REMARKS

ANNOTATED MARKED-UP DRAWING.

Fig. 1

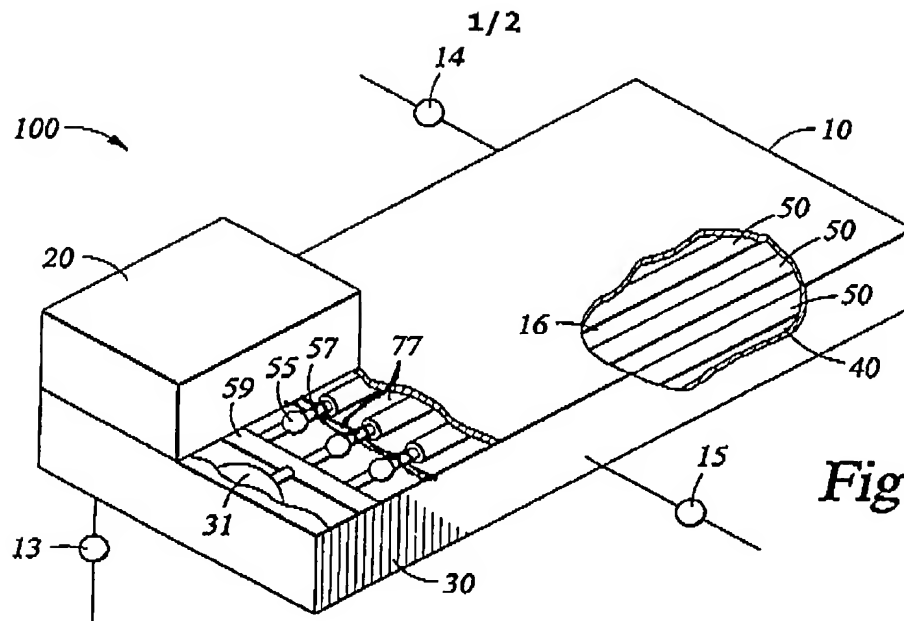
3. The drawings have been amended to overcome Examiner Leung's objections. "Annotated Marked-Up Drawing" sheet 1, submitted herewith, shows dividing walls 77 and inlet line 21 as described in the specification.
